M24M01-DF package mechanical data modifications

This errata sheet applies to the M24M01-DF, which is 1 Mbit serial I²C bus EEPROMs, and specifically to the device delivered in 8-bump wafer-level chip-scale packages (WLCSP).

The impacted part number is M24M01-DFCS6TP/K.

Figure 3. D and E back side view

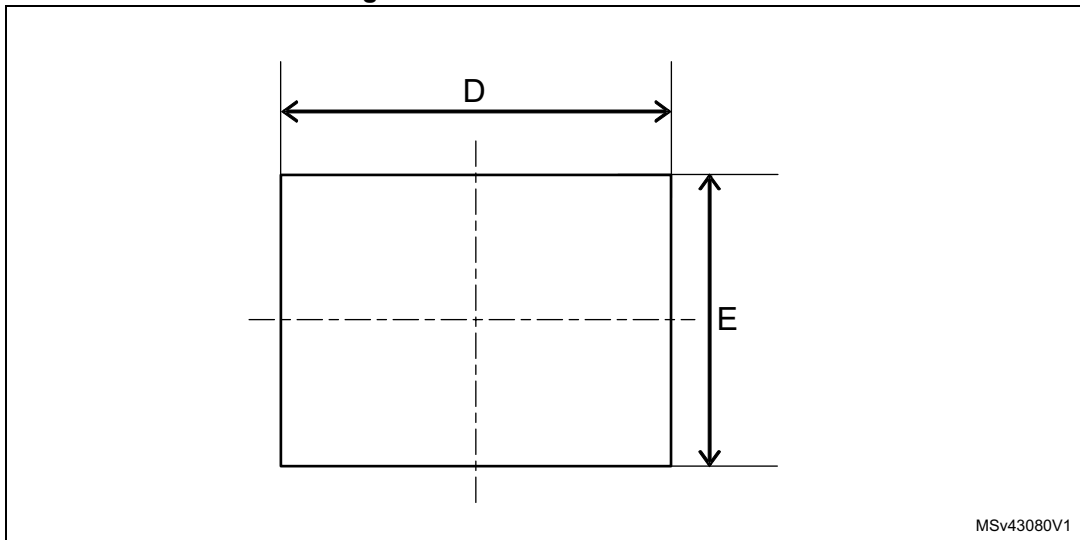
This document refers to the changes in dimensions D and E (see [Figure 3](#)) described in the M24M01-DF datasheet, in tables detailing the dimensions of the WLCSP 8-bump package.

D and E values must be modified to correct the following mistake:

- The D and E values in the M24M01-DF datasheet correspond to front side view (ball side), instead of back side view (marking side view).
[Table 1](#) and [Table 2](#) report the data for the front and back view, respectively.

Table 2. D and E values corresponding to back side view

Symbol	Millimeters			Inches		
	Min	Typ	Max	Min	Typ	Max
D	-	2.578	2.598	-	0.1015	0.1023
E	-	1.716	1.736	-	0.0676	0.0683

Figure 4. D or E side view

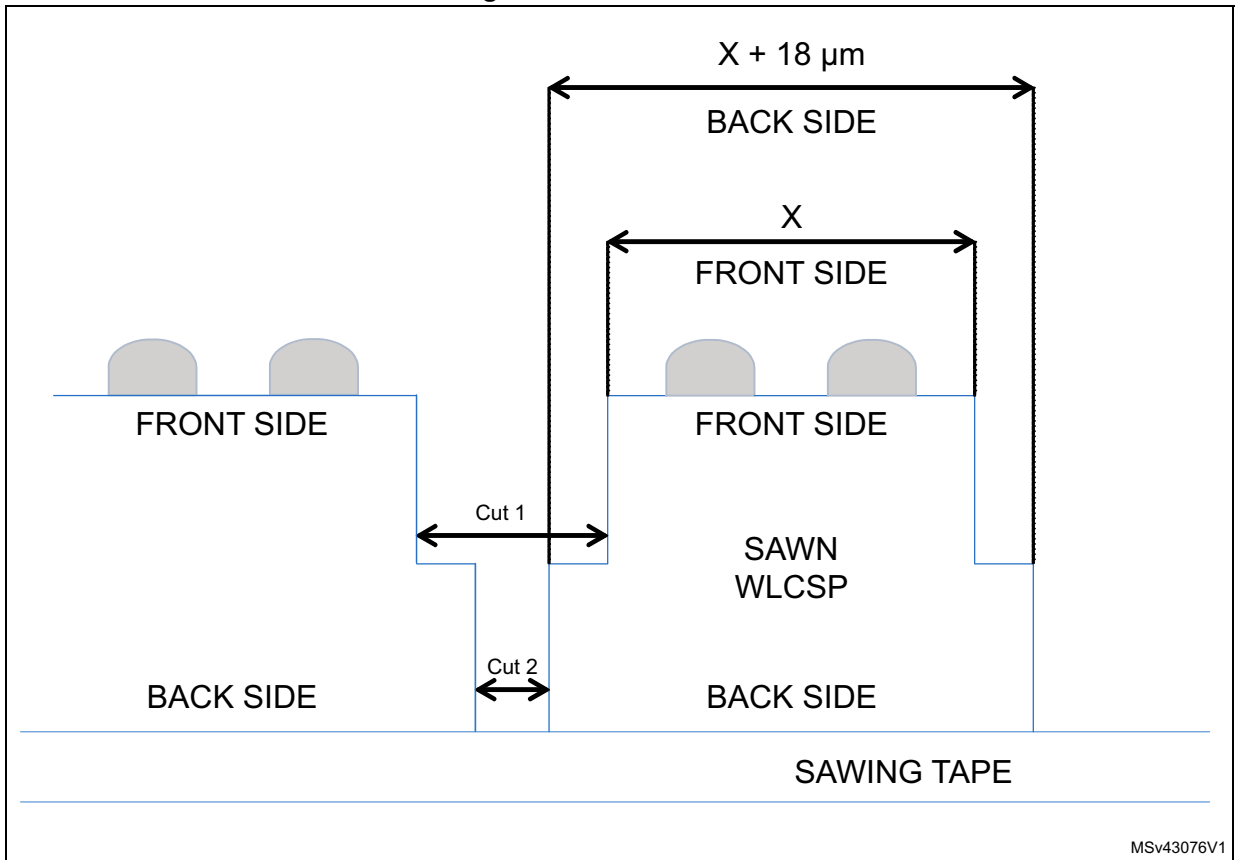
The difference between back side and front side dimension is 18 µm (0.018 mm). This difference is due to the two-step sawing process, where cut 1 and cut 2 are performed with blades having different thicknesses (see [Figure 4](#) in which X represents D or E and it has the same value and tolerance).
